# UNITED STATES PATENT AND TRADEMARK OFFICE

APPLICATION NO.	FILING DATE	FIRST NAMED INVENTOR	ATTORNEY DOCKET NO.	CONFIRMATION NO.
10/591,060	08/30/2006	Ryusuke Fujiyoshi	DK-US040214	6483
22919 7590 03/18/2010 GLOBAL IP COUNSELORS, LLP 1233 20TH STREET, NW, SUITE 700 WASHINGTON, DC 20036-2680				
EXAMINER				
ROGERS, LAKIYA G				
ART UNIT		PAPER NUMBER		
3744				
MAIL DATE		DELIVERY MODE		
03/18/2010		PAPER

### Office Action Summary

### DETAILED ACTION

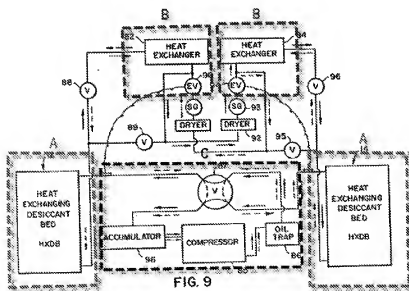
**Regarding claim 2**, Rhodes teaches in Fig. 9 an air conditioning system capable of treating a latent heat load and a sensible heat load in a room by performing a vapor compression refrigeration cycle operation comprising: a plurality of first utilization side refrigerant circuits (indicated as "A" in annotated Fig. 9 below) each having an absorbent heat exchanger (12,14) provided with an adsorbent on a surface thereof capable of alternating between an absorption process in which moisture in air is adsorbed onto the adsorbent by causing the adsorbent heat exchanger to function as an evaporator that evaporates refrigerant (Col. 17, lines 15-23) and a regeneration process in which moisture is desorbed from the adsorbent by causing the adsorbent heat exchanger to function as a condenser that condenses the refrigerant and connected in parallel with one another (Col. 11, lines 63-67); and a plurality of second utilization side refrigerant circuits (indicated as "B" in annotated Fig. 9 below) capable of exchanging heat between refrigerant and air and connected in parallel with one another, the first utilization side refrigerant circuits being capable of supplying a room with air that passed through the adsorbent

heat exchanger and the second utilization side refrigerant circuits being capable of supplying a room with air that passed through the heat exchangers; a heat source side refrigerant circuit (indicated as "C" in annotated Fig. 9 below) including a compression mechanism (85); the first utilization side refrigerant circuits being connected to a discharge gas connection pipe (piping between compressor 85, oil trap 86, and valve 87) connected to a discharge side of the compression mechanism (85) and being connected to an inlet gas connection pipe (piping between valve 87 and accumulator 96) connected to an inlet side of the compression mechanism (85, by way of piping and accumulator).

Rhodes fails to explicitly teach a heat source side heat exchanger in the heat source side refrigerant circuit.

However, it would have been obvious to a person of ordinary skill in the art at the time of invention to modify the system of Rhodes to replace the accumulator (96) with a heat exchanger in order to ensure that mixed phase refrigerant is in the liquid phase before being sent to the inlet of the compressor. A person of ordinary skill in the art at the time of invention would recognize that incorporating a heat exchanger in this manner will ensure any gas of a mixed phase refrigerant is condensed before entering the compressor in order to prevent compressor damage in turn maximizing the life of the compressor.

Therefore it would have been obvious to a person of ordinary skill in the art at the time of invention to modify the system of Rhodes to replace the accumulator in the heat source side refrigerant circuit with a heat exchanger in order to prevent compressor damage and in turn maximize the life of the compressor.

**Regarding claim 4**, Rhodes as modified above teaches the invention as recited above and further teaches that the second utilization side refrigerant circuits ("B") are connected to a liquid connection (piping between heat exchangers 82,84 and desiccant heat exchangers 12,14

depending on operating mode) that is connected to a liquid side of the heat source side heat exchanger (by way of piping and valve 87) and switchably connected to the discharge gas connection pipe and the inlet gas connection pipe through a switching mechanism (valve 87).
